AS-390/SRC, AT-150/SRC REPAIR METHODS FOR MATCHING SECTION

COMMUNICATIONS

NAVSEA 0967-LP-000-0010

SERVICE NOTES

Figure 1. Whip Antenna Platform Modification
(EIB 938)

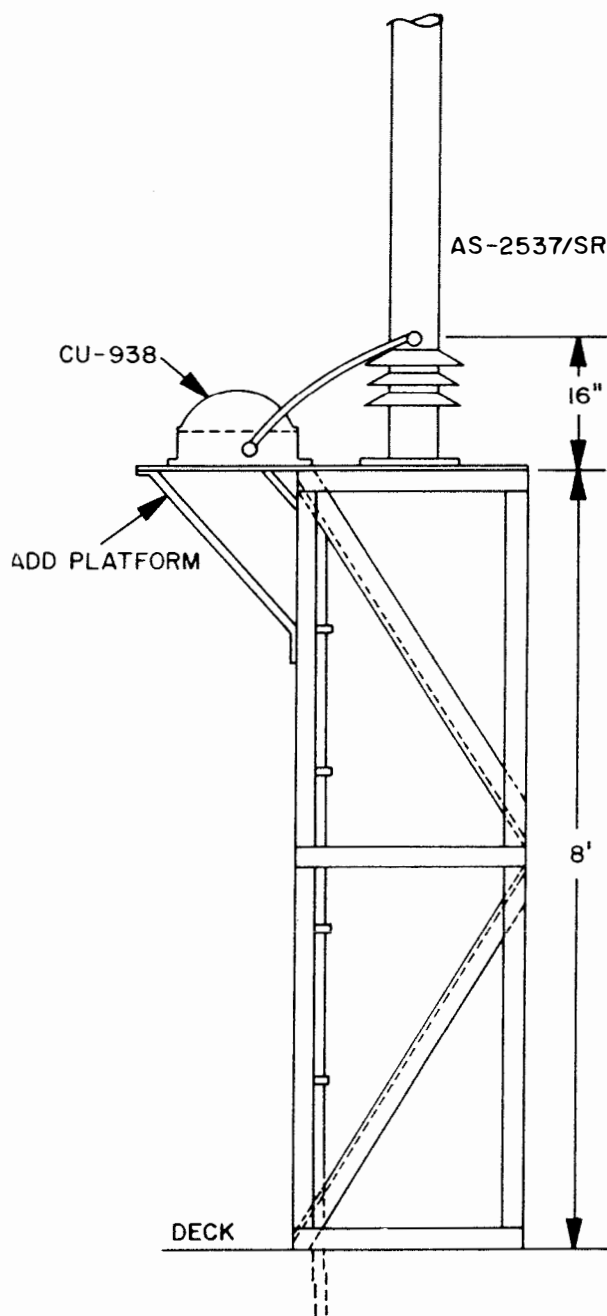
Installation instructions require the interconnection to be not more than 36" (preferred length is 12" or less) with a clearance of 6" in any direction. NAVSHIPS 0967-177-3020, SHIPBOARD ANTENNA SYSTEMS, VOLUME 2, INSTALLATION DETAILS, paragraph 3.2.2 requires that the antenna coupler be located above the antenna mounting platform. A recommended modification to existing mounting platforms is shown in Figure 1. To preclude the expense of running new cables, and to eliminate unnecessary adapters, the existing coaxial cable (RG-218/U or RG-219/U) may be extended by a short length of RG-214/U fitted at one end with a UG-21F/U plug and at the other end with a UG-23F/U jack. The control cable may be extended by use of a short length of MSCU-37 fitted at one end with an MS3101R28-21P receptacle and at the other end with an MS3106R28-21S plug.

Some installations have been noted where the antenna coupler was properly installed for a fiberglass whip but was feeding an aluminum whip, with the interconnecting cable going down through a stuffing tube to connect to the feed point. In this situation, it is recommended that the antenna be fed at one of the mounting bolts which connects the antenna adapter base to the base insulator.

FIGURE 1

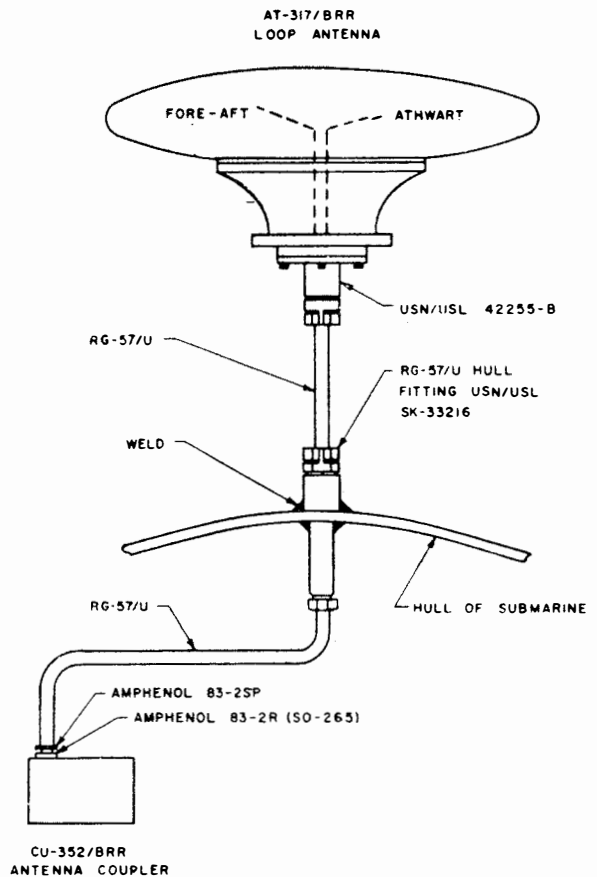
Recommendations to correct this default is contained in the following paragraphs. (See figure 1)

Plug; cable to antenna: Make plugs locally as required in accordance with USN/USL drawing 42255B and associated details. One special O-ring is required. Both the drawing and the O-ring are available, until further notice, from U.S. Navy Underwater Sound Laboratory, New London, Connecticut, Code 1316. FSN N5330-585-1363 has been assigned to the O-ring by ESO but none are in stock yet. The use of this plug eliminates the need for making a flange or welding a hull fitting to the flange or to the antenna base. This plug will fit into the AT-317/BRR with no changes of the antenna.

Receptacle: The CU-352/BRR coupler must be modified by replacing the large existing receptacle with the twinax receptacle identified as UG-1057/U, NT 49196, Signal Corps type SO-265, or Amphenol 83-2R. FSN N5935-149-2856 applies.

Figure 1. Bottom view of joint between antenna subassembly & mounting base of AT-317/BRR.

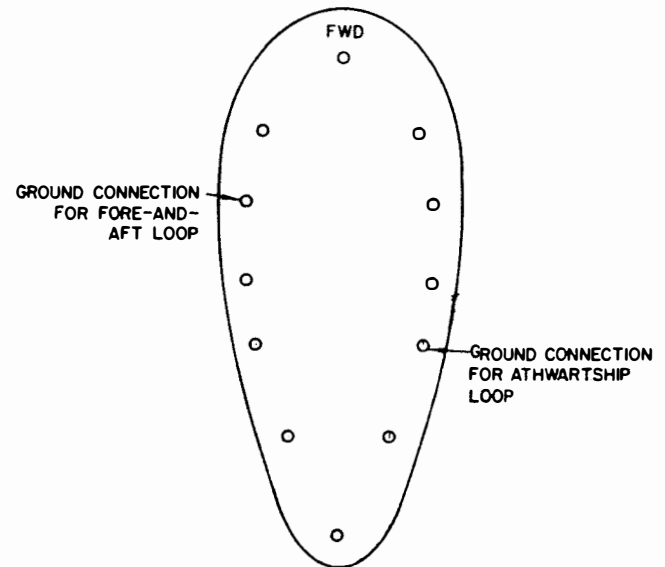
Figure 1 is the bottom view of the joint between the rubber-covered antenna and the metal mounting base. Twelve 7/16 inch-28 x 1-inch long socket-head cap screws fasten them together. If the forward cap screw is considered the 12-o'clock position, the one at 4 o'clock is the ground connection for the athwartship loop, and the one at 10 o'clock is for the fore-and-aft loop.

After the two bolts are removed, the insulation resistance can be measured from the radio room. Assuming that the system is assembled properly, a low resistance reading (10,000 ohms or less) here means that the antenna is flooded. In this case the antenna must be removed from the ship. It is sometimes possible to restore the antenna to satisfactory operating condition by removing the mounting base, rinsing the antenna thoroughly to remove salt, and drying under a heat lamp (being careful not to overheat) for a period of a few days, until the insulation resistance is at least 50,000 ohms.

Figure 1. DG-1 Diode Waveform

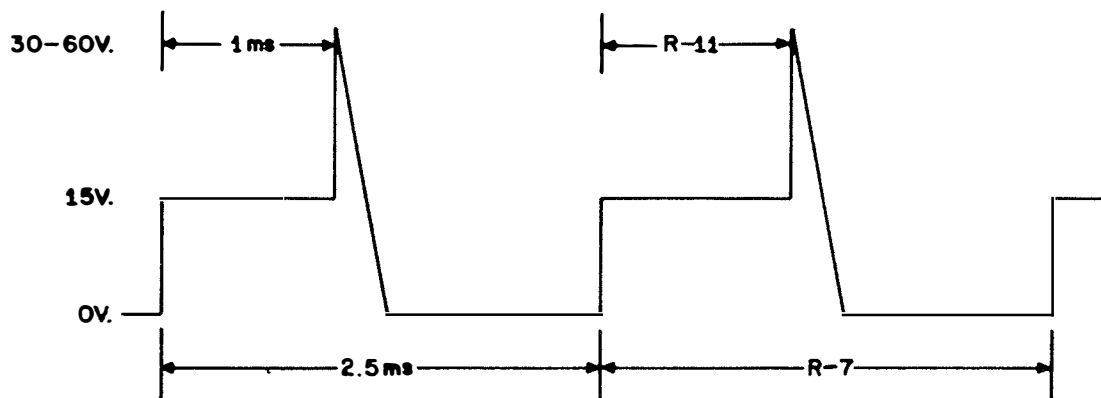
- b. Frequency Adjustment:
 1. Connect scope probe to left side of DG-1 diode in top middle of controller cabinet (Item 2 of figure 1-6 of NAVSHIPS 0967-059-5112).

4. Turn on circuit breaker and check output as shown in figure 1. (772)

Figure 1. Top View of Coupler, Showing Location of Metal Pin.

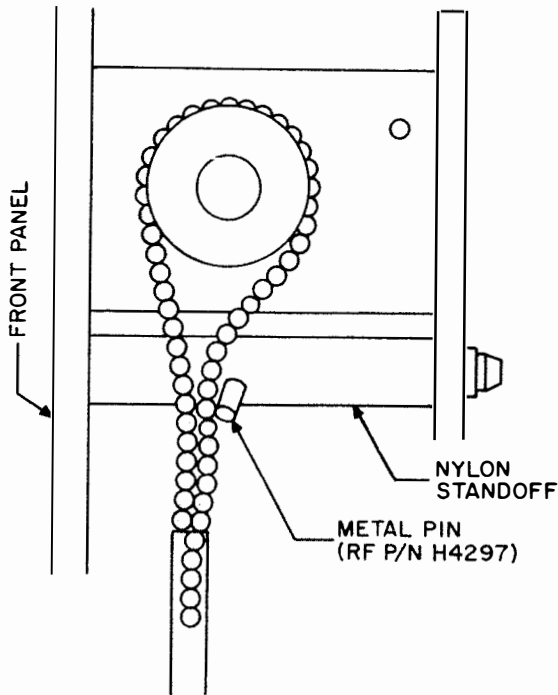
A metal pin (RF Communications part/number H4297) is installed in the nylon standoff which is located approximately 3/8 inch below each three digit counter drive sprocket. See figure 1 for identification. A 0.089-inch diameter hole must be drilled into the standoff 1/2 inch from the end which is flush with the front panel.

Figure 2. Drilling and Installation Details (E1B 721)

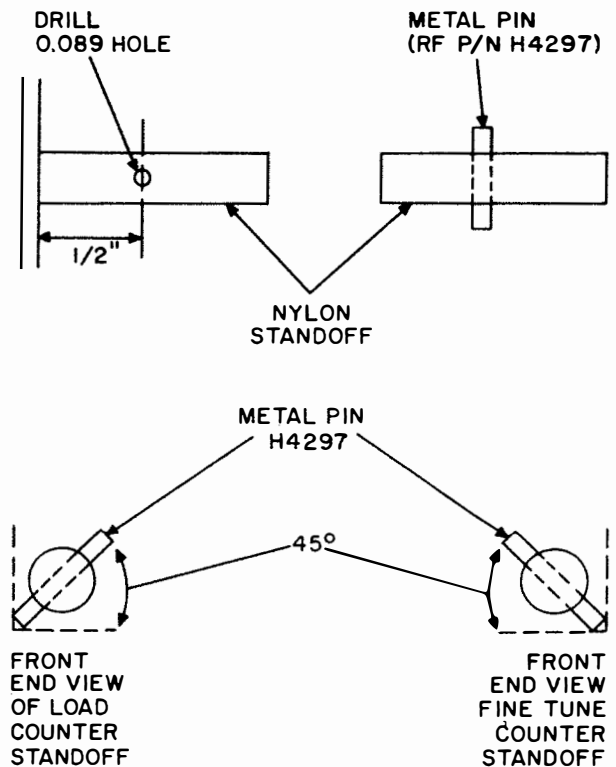
The hole should be drilled at a 45° angle into the standoff to provide clearance between the top cover of the antenna coupler and the metal pin.

Insert the H4297 pin into the hole as shown in figure 2. Route the chain around the pin, as shown in figure 2,

**CORRECTIONS TO SCHEMATIC DIAGRAM
FIG. 6 OF NAVSHIPS 91394**

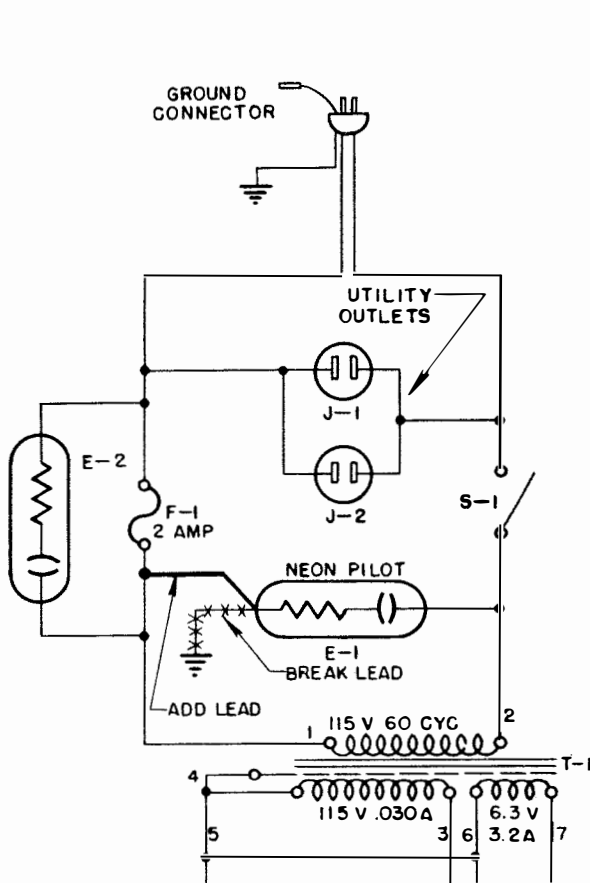
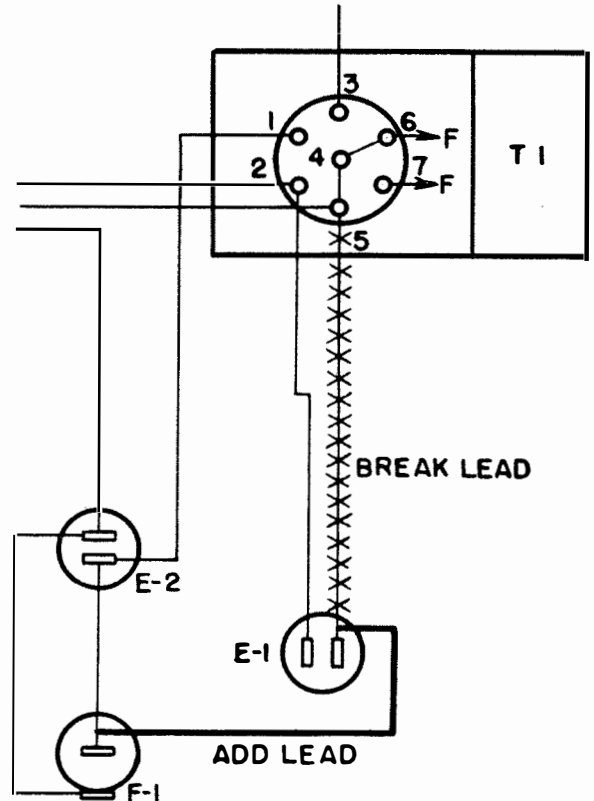
Field activities have reported that the on-off indication of the neon pilot lamp (E1) of Frequency Shift Converter CV-172/U is not definite when the converter is operated from an ungrounded primary power input line. For this type installation, the Bureau authorizes a rewiring of lamp E1 in accordance with accompany-illustrations.

These diagrams are intended as an aid in rewiring E-1. It is not a complete drawing of the CV-172/U.

A field change will not be issued for this minor modification; however, appropriate entries to indicate rewiring of E1 should be made in the equipment history cards and instruction books.

Figure 4. Litton Indicator Transmitter Shim for Differential Unit Assembly. (From Dwg. SK4270035, Rev. A.)

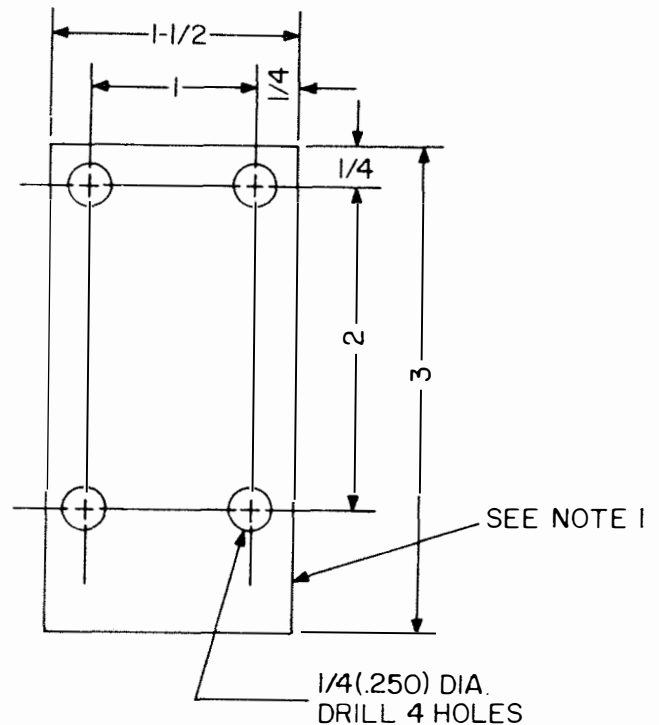
Correspondingly, the same philosophy exists for the shimming of the Differential Unit Assembly. Figures 4 and 5 depict the manufacture of both shims for the Differential Unit Assembly. The basic concept of the alignment procedure for the Time Motor can be applied to the Differential Unit Assembly. Any questions concerning this article, can be directed to NAVSECNORDIV, Tom K. Kamalsky, Jr. Autovon 690-9325.

Figure 1. STELMA Model LC-3 Constant Current Rheostat

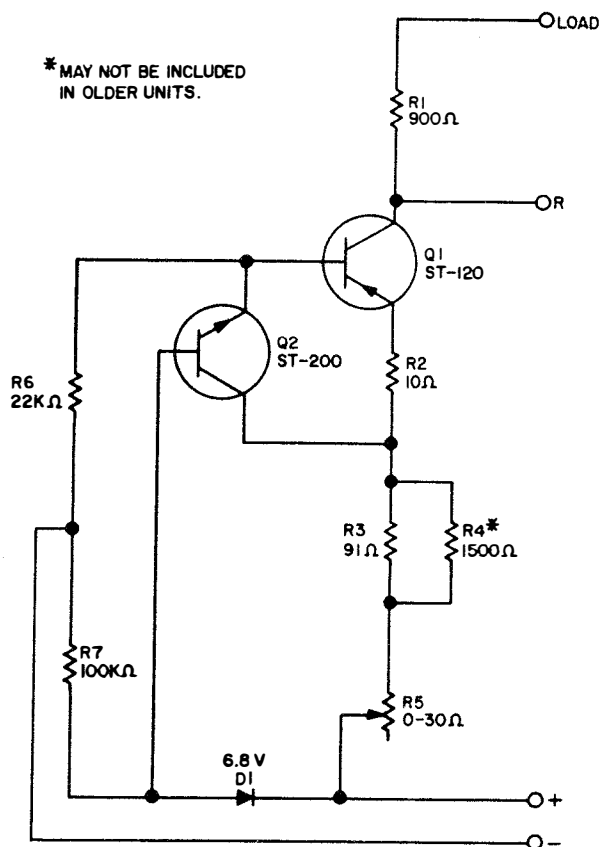
Two mechanical configurations of the LC-3 rheostat are being used. The circuit, figure 1, is the same for both configurations. Figure 2 and figure 3 show the general component layout of the units. Table 1 is a description of all components in the LC-3. These components are generally available through supply channels.

Figure 4. Test Set Up

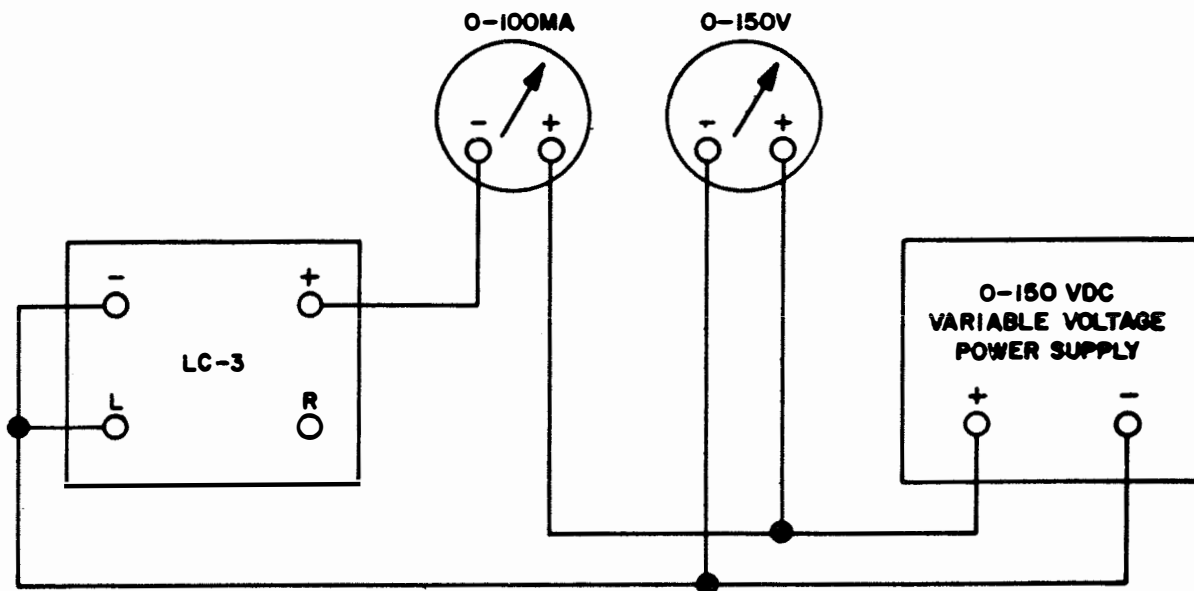
1. Connect terminals L and - to the negative side of the DC supply as shown in figure 4.
2. Set up one meter to measure 0-100 MA and place it in series with a line from the LC-3 + terminal to the DC supply + terminal.
3. Connect the other meter to measure the power supply DC voltage.
4. Turn the supply on and adjust the output to 100 volts.
5. Adjust the LC-3 potentiometer for 60 MA current.
6. While observing the MA meter, vary the voltage of the power supply between 65 and 135 volts. A properly functioning LC-3 should maintain 60 MA \pm 2 MA over the entire 65 to 135 volts range.
